REVIEW OF AN ENVIRONMENTAL ASSESSMENT

THE PROPOSED REDEVELOPMENT OF CRONULLA MARINA

60 Waratah Street, Cronulla

**ON BEHALF OF: NSW DEPARTMENT OF PLANNING
Representative: David Kitto, Director, Major Development
Assessment.
23-33 Bridge Street, Sydney NSW 2000**

Fig. 2.4 – Proposed Marina Development Vessel Count Consistent with the EP&A Act.

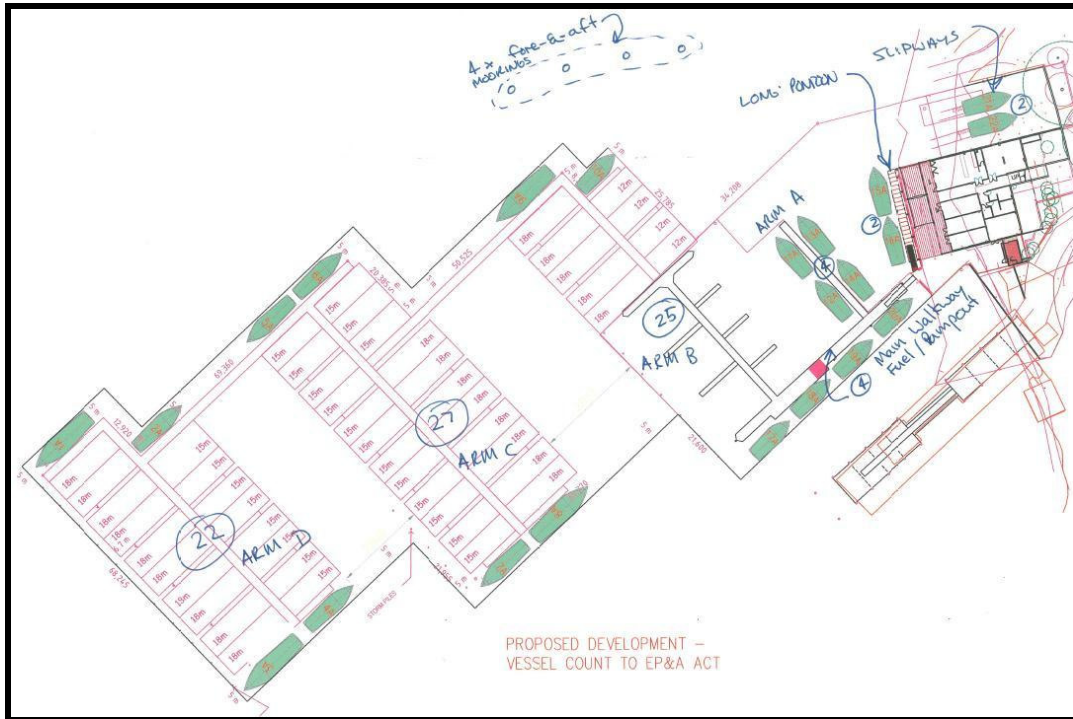
The proposed marina development should maintain a vessel count consistent with the EP&A Acts definition of a “Berth”. We note that the proposed development has a proposed lease area offset 5m from the marina structure. This would infer that the Proponent intends to use the outer face of ‘T’ heads and lengths of main walkways for either casual or permanent berthing, as there would be available lease area outside of the structure to permit this use. Additionally Arm A appears to have been made available for casual berthing. As such we determine the proposed marina Development has having the following vessel count.

- Arm A – Four (4) Casual Berths.
- Main Walkway / Fuel / Pumpout Facility – Four (4) Casual Berths.
- Slipways – Two (2) berths up to 18m.
- Long Pontoon fronting the Proposed Restaurant – Two (2) Casual Berths.
- Arm B – 25 Floating Permanent Berths. We note that two (2) may / can be used on a casual basis.
- Arm C – 27 Floating Permanent Berths. We note that four (4) may / can be used on a casual basis.
- Arm D - 22 Floating Permanent Berths. We note that four (4) may / can be used on a casual basis.
- Fore-&-Aft Moorings – Four (4) are proposed
- We calculate that under the EP&A Act the total number of berths proposed in this development is 90, Ten (10) more than the existing number of Berths.

We recommend that the count for the existing and proposed number of berths be amended to 80 Existing (78 if slipway storage is excluded from the count) and 90 Proposed (88 if slipway storage is excluded from the count). We recommend that the Development be determined based on the above mentioned vessel counts.

Fig. 3.2 – Proposed Lease Areas.

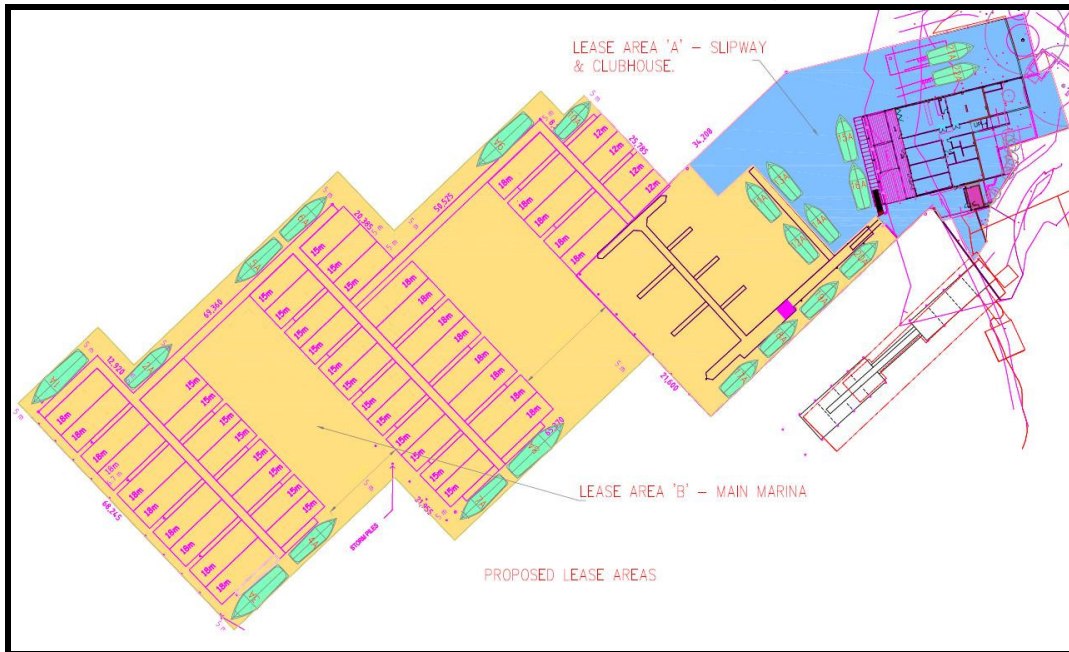
- We note that the proposed development, in plan footprint, has an area of 16,161m² or 293% larger than the Department of Lands calculation of the existing lease area.

We believe that the lease area is excessive and that there remains scope to further consolidate the required number of marina berths in a smaller lease envelope. We recommend that the Proponent revises the design to minimize the increase in lease area. This item is covered further in this document under Vessel Mix.

Fig. 4.3 – Navigation Channels

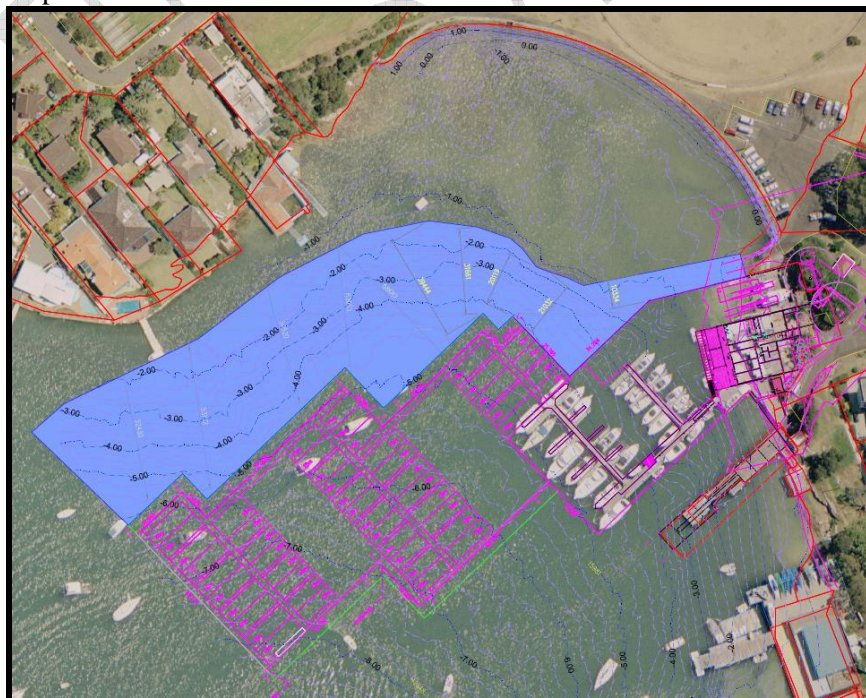
The minimum navigation channel width north of the proposed marina is 21m (subject to the four (4) fore-&-aft berths being removed). The current maximum requirement for public vessels is 12m and for the marina is 15m. Moving west from Arm B to Arm D the navigation channel increases in width to 68m with an average width of over 50m, more than sufficient for all expected vessel movements in this area of the Bay. We are of the opinion that the proposed development meets all navigation channel width requirements as set out in AS3962-2001 Clause 3.1.1.

We note the proposed location of the four (4) fore-&-aft moorings and

given the frequency of vessel use associated with the existing public boat ramp, the Proponents slipways and the Long Pontoon and Arm A casual berthing facilities there would be a significant reduction of navigation channel width should these fore-&-aft moorings remain. We recommend their removal from the development. Secondly, the navigation channel from the public boat ramp may be further restricted by an increase in sedimentation. There is merit in the Proponent looking at either the completion of remedial dredging to the immediate west and southwest of the public boat ramp, financing an increase in width at the public boat ramp or the completion of both. The scope of the Proponents proposed development should be able to cover these works. Given that further sedimentation is expected in the Bay and that the proposed development would form a barrier preventing the public boat ramp channel from moving to suit this further sedimentation, we recommend that the Proponent be responsible for any further remedial dredging fronting the public boat ramp to ensure that this important public asset is retained.

- 4.10.2 We recommend the removal of the four (4) fore-&-aft moorings. These berths should be incorporated into the marina footprint if required.
- 4.10.3 We recommend that the Proponent reviews dredging the immediate surrounds of the existing Public boat ramp to increase accessibility, amenity and safety. The Proponent should be made responsible for remedial dredging of the navigation channel to the public boat ramp to maintain channel depths.

- 4.10.4 We recommend that the Proponent places three (3) navigation markers running along the north western edge of the navigation channel from the public boat ramp to a line perpendicular to Arm ‘B’ and that these be located by the NSW Maritime Authority.
